# UNITED STATES PATENT AND TRADEMARK OFFICE

APPLICATION NO.	FILING DATE	FIRST NAMED INVENTOR	ATTORNEY DOCKET NO.	CONFIRMATION NO.
10/808,954	03/25/2004	Robert T. Tippmann	ACC0005-01	6357
832	7590	01/18/2006	EXAMINER	
BAKER & DANIELS LLP 111 E. WAYNE STREET SUITE 800 FORT WAYNE, IN 46802			COCKS, JOSIAH C	
			ART UNIT	PAPER NUMBER
			3749

<b>Office Action Summary</b>	<b>Application No.</b>	<b>Applicant(s)</b>	
	10/808,954	TIPPMANN, ROBERT T.	
	<b>Examiner</b>	<b>Art Unit</b>	
	Josiah Cocks	3749

## DETAILED ACTION

Segment of Fig. 1 of Lewus '571

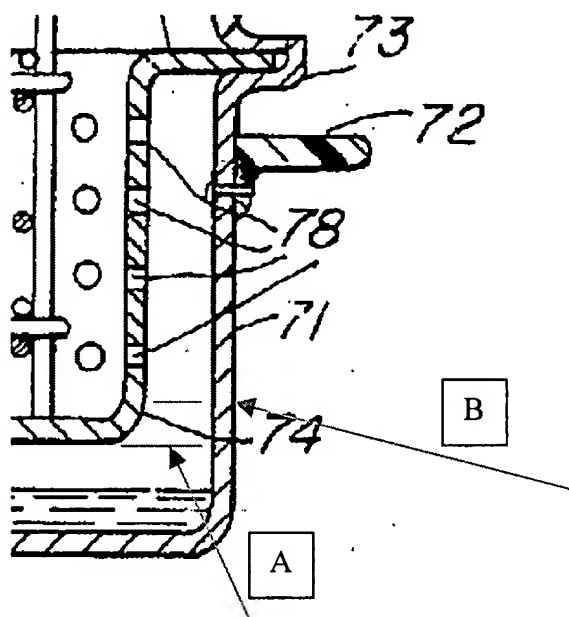
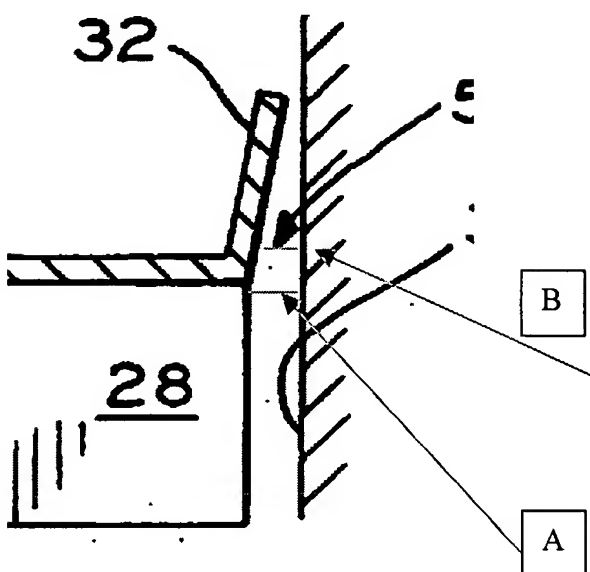
Regarding the recitation that the passage is tapered, the examiner has noted that the conduits shown in Fig. 1 of Lewus '571 formed between pan (74) and base member (71) are illustrated as tapered. The term “tapered” is defined by Webster's II New Riverside University dictionary (1984) as “a gradual decrease in width or thickness or an elongated object.” A segment Fig. 1 is reproduced below and compared with an exemplary embodiment of applicant's tapered passage shown in Fig. 3.

The examiner has added the lightened arrows, reference characters A and B, and comparative lines to each drawing. The examiner considers that the portions indicated with the added lines and reference characters A and B illustrates that the width of passage formed between pan (74) and member (71) are properly considered to be gradually decreasing in the same manner shown by applicant's panel (32) and the hatched sidewall and is therefore properly considered tapered (note the comparative reference characters A and B and lightened lines).
